**Palo Verde
Nuclear Generating Station**
P.O. Box 52034
Phoenix, AZ 85072
Mail Station 7605
Tel 623.393.6491

Subject: **Palo Verde Nuclear Generating Station (PVNGS)
Units 1, 2, and 3 and Independent Spent Fuel Storage Installation
Docket Nos. 50-528, 50-529, 50-530 and 72-44
License Nos. NPF-41, NPF-51 and NPF-74
PVNGS Emergency Plan, Revision 62**

PVNGS Emergency Plan, Revision 62

FIGURE 2 TECHNICAL SUPPORT CENTER ORGANIZATION

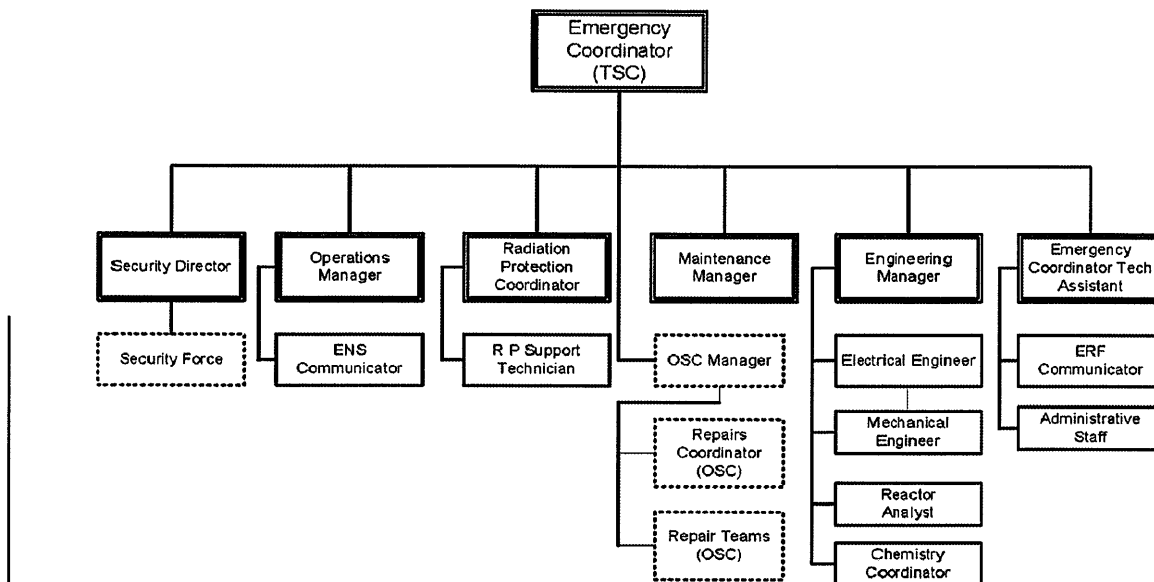
- Page 43 Removed the Shift Technical Advisor and Safety Analysis Engineer from Figure 2
- Page 45 Removed Information Coordinator and System Engineer from Figure 4

FIGURE 7 STATE, COUNTY & LOCAL EMERGENCY OPERATIONS CENTER ORGANIZATION

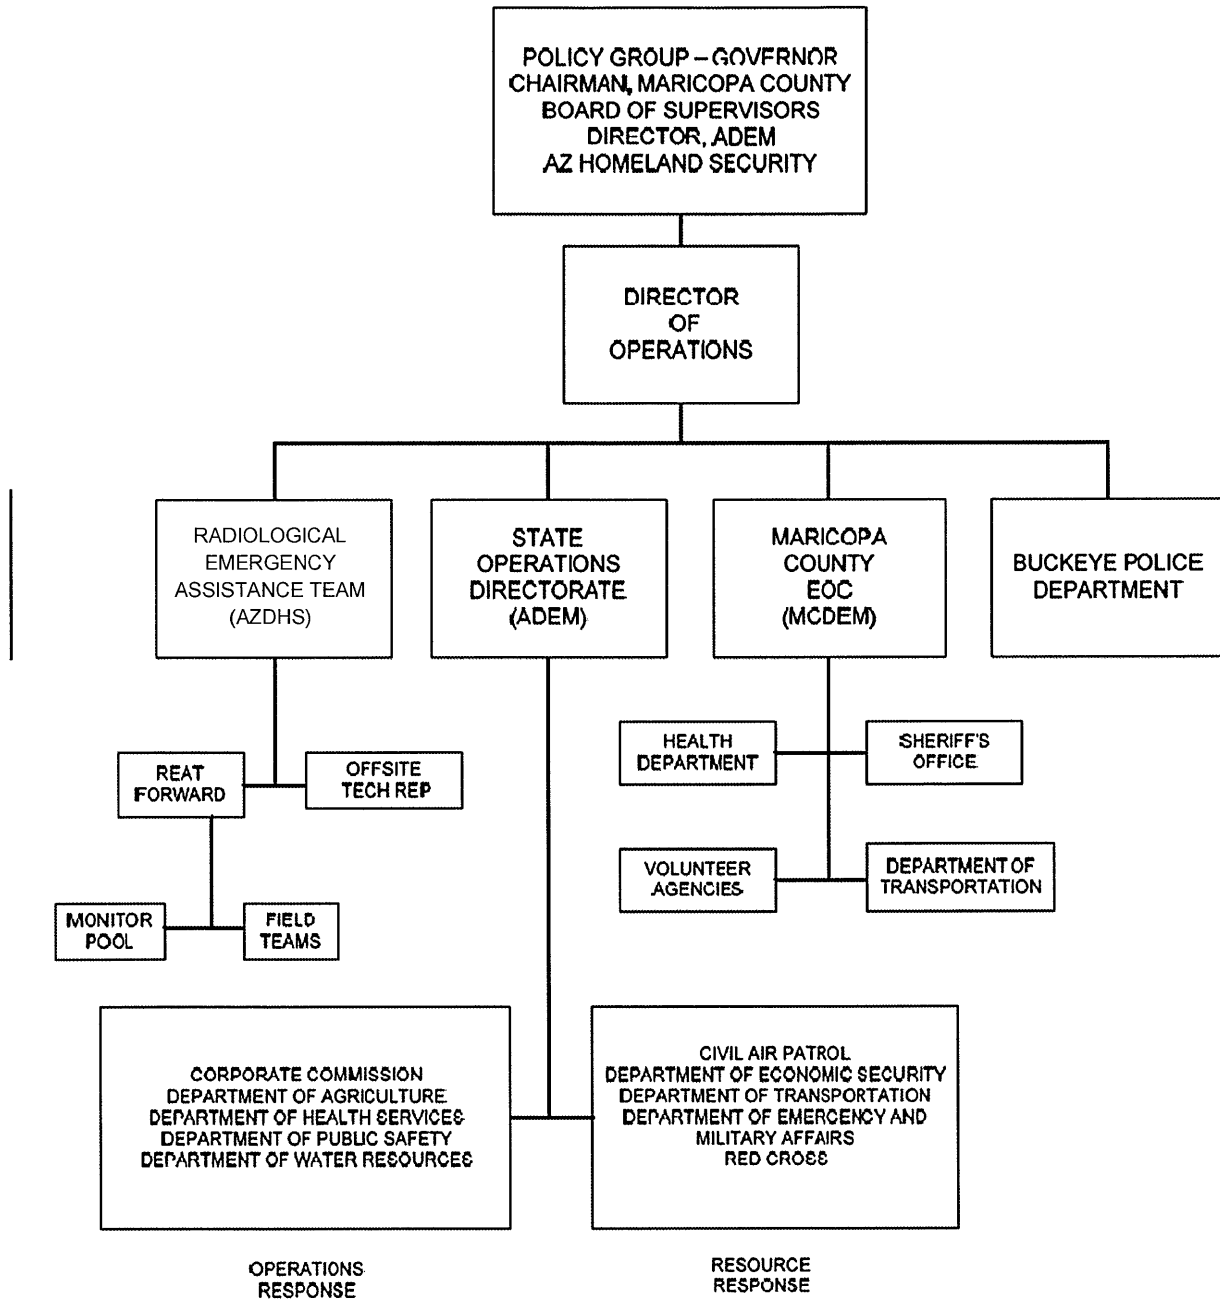
- Page 48 Changed to Radiological Emergency Assistance Team (AZDHS)
- Page 53 Changed Palo Verde NGS to PVNGS
- Page 53 Added the phrase “... or other approved methodologies...”

Change 24	
Summary of Change in the Emergency Plan:	Figure 7, Page 48 – Changed to Arizona Department of Health Services (AZDHS)
Current Revision	RADIOLOGICAL EMERGENCY ASSISTANCE TEAM (ARRA)

FIGURE 8 NOTIFICATION ALERT NETWORK (NAN)

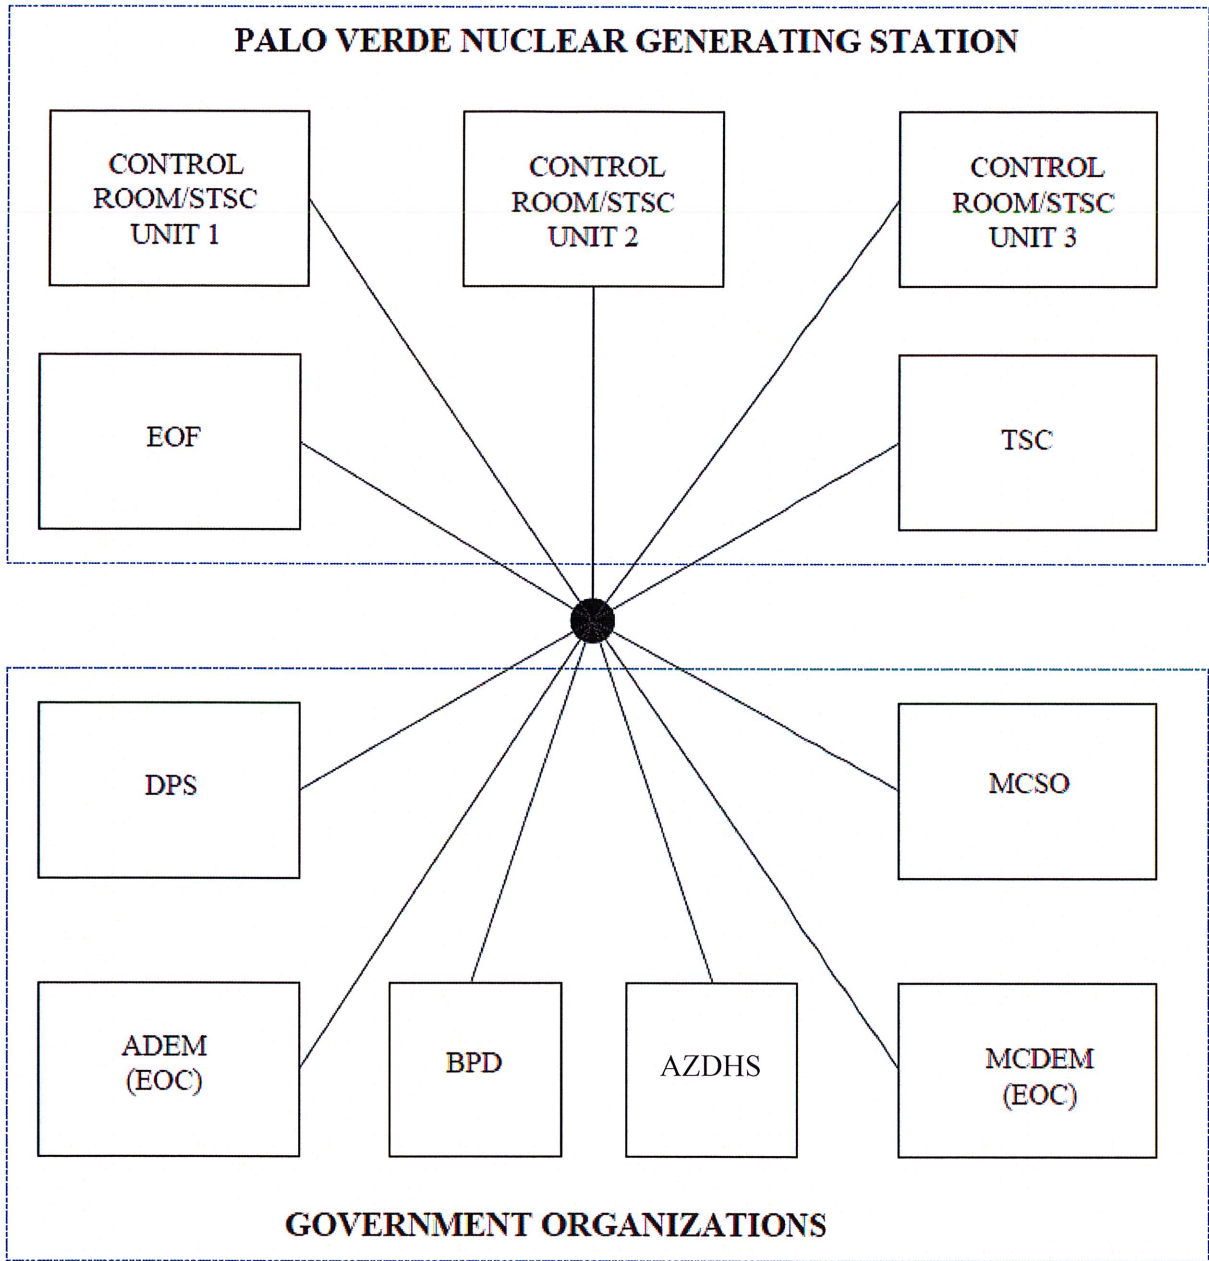
- Page 63 Changed the name of ARRA to AZDPH on Figure 8
- Page 64 Changed the name of ARRA to AZDHS on Figure 9
- Page 75 Added the description of cellular phones being assigned to facilities.

Change 36	
Summary of Change in the Emergency Plan:	Figure 8, Page 63 - Changed the name of ARRA to AZDHS on Figure 8.
Current Revision	ARRA is listed on Figure 8.
Change	AZDHS is listed on Figure 8.
